Memo

To: Kathryn Espinoza, McKim & Creed
From: Brian Chambers, Senior Planner; 910.342.2782
CC: File;
Date: 2/17/2021
Re: Riverlights MX3 Road Improvements TRC Rev. 3

SIGNAGE AND PAVEMENT MARKING PLAN:

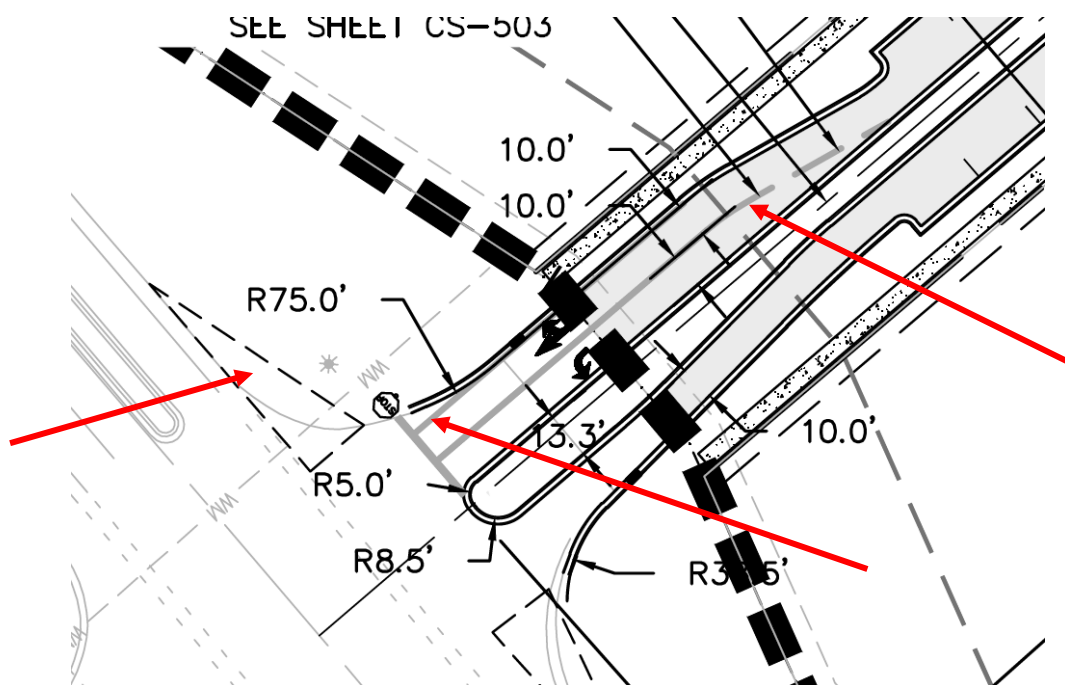
- Remove an additional pavement marking for the through/Right turn lane in below image at Ledbury Rd/River Rd.
- Dimension the length for taper (shown with white mini-skip lines) and left turn lane bays at both the street intersections with River Rd.
- Differentiate between white mini-skip and turn lane line types for Arnold Rd/River Rd.
- Dimension the width of the striped median at the Arnold Rd/River Rd.
